1984 - 1986 Corvette: Service Bulletin: Window Regulators - Replacement

Number: REISSUE 86-17

Subject: WINDOW REGULATORS

Model and Year: 1984-1986 CORVETTE

WINDOW REGULATOR ASSEMBLY

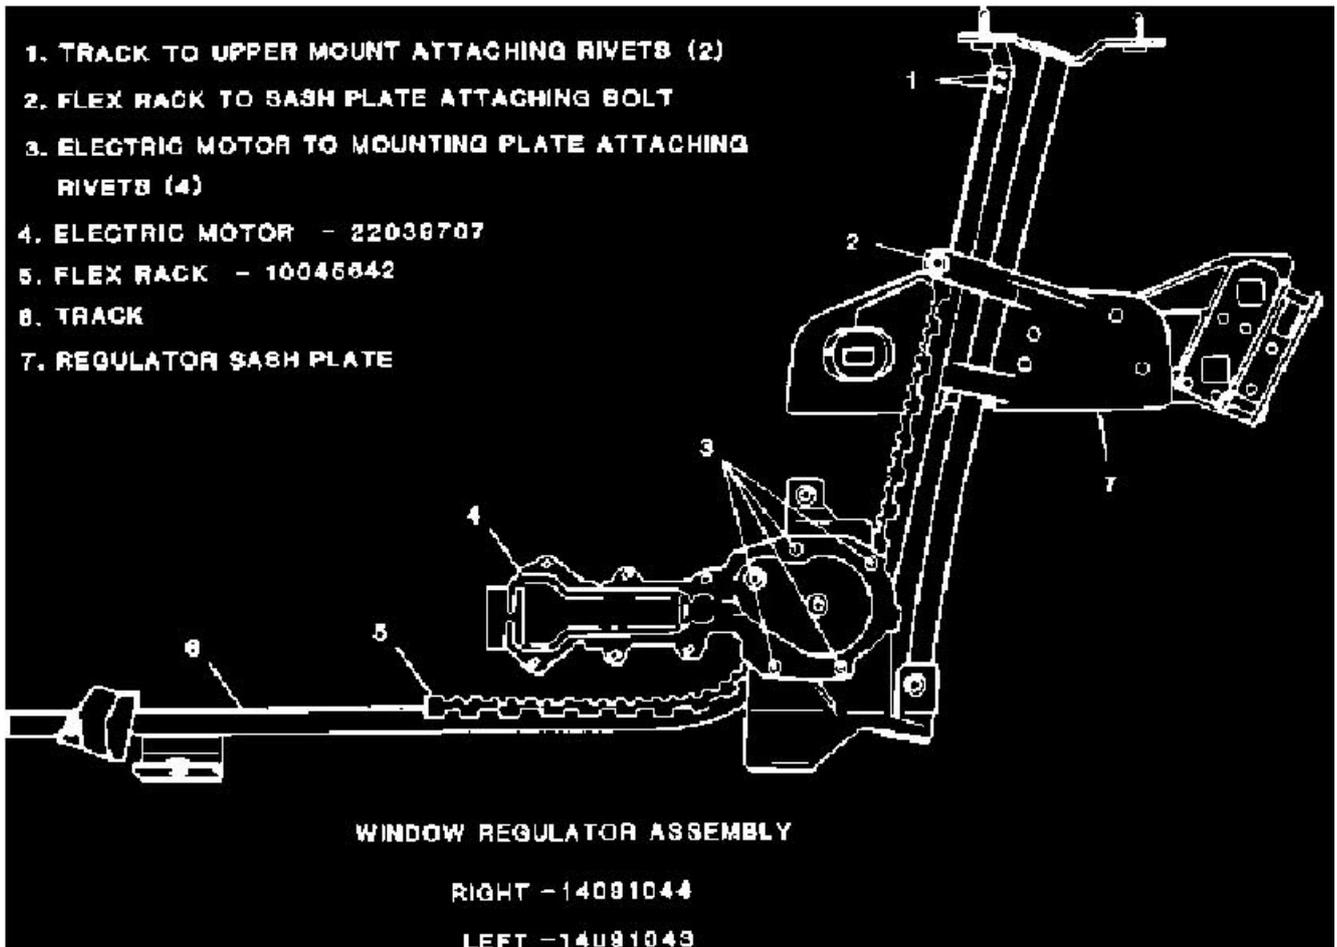
Conditions which in the past required complete window regulator replacements on Corvettes, can now be repaired by either replacing the complete regulator or servicing the existing regulator with component parts.

This bulletin contains part numbers and procedures for the replacement of the electric motor and plastic flex rack of the window regulator assembly (Items 4 and 5, Figure 1).

Regulator conditions encountered on vehicles built prior to September, 1984 or that have flex rack tracks which are not chrome, (Item 6, Figure 1) but are yellow or gold in color, or dull metal finish, require replacement of complete regulator assembly.

Conditions encountered on vehicles built after August, 1984 or regulators with chrome flex rack tracks (Item 6, Figure 1) may be repaired with component parts (electric motors and or revised flex racks, Items 4 and 5,

Figure 1).

1. Remove regulator assembly from door and place on a clean work surface.
2. Using an electric drill. motor and 4mm (5/32") drill bit, drill out four (4) attaching rivets that retain the electric window motor to the 1986 Chevrolet Corvette V8-350 5.7L Copyright © 2006, ALLDATA 8.80 Page 2 lower mounting place (location 3, Figure 1).

3. Remove the motor from the regulator assembly and transfer the plastic drive gear to the new motor.
4. Clean the lower mounting plate of all metal shavings prior to motor installation.

5. Apply lubricant (GM P/N 1052349 or equivalent) to the drive gear, flex rack, track and gear housing on the lower mounting plate.
6. Install the new motor to the mounting plate using four (4) 4 mm X 10 mm (5/32" X 3/8") rivets (location 3, Figure 1).

2. Using an electric drill motor and 4mm (5/32") drill bit, drill out the two (2) track to upper mounting plate attaching rivets (location 1, Figure 1).

3. Remove the Allen head type bolt (location 2, Figure 1) retaining the flex rack to the regulator sash plate. It will be necessary to hold the attachment nut on the underside of the sash plate to prevent it from rotating.

4. Lift track away from upper mounting plate and carefully pull track away from guide tube in order to disengage the flex rack and track from the sash plate opening at location 2, Figure 1.

9. Locate the flex rack and track into the sash plate opening at location 2, Figure 1. Apply Loctite Thread Sealer to the bolt threads prior to reinstalling the Allen type bolt at location 2, Figure 1 to prevent loosening from vibration.

10. Locate and fasten track to the upper mounting plate using two (2) 4mm X 10mm (5/32" X 3/8") rivets (location 1, Figure 1).
11. Using an external power source, operate the regulator to insure quiet, free operation.
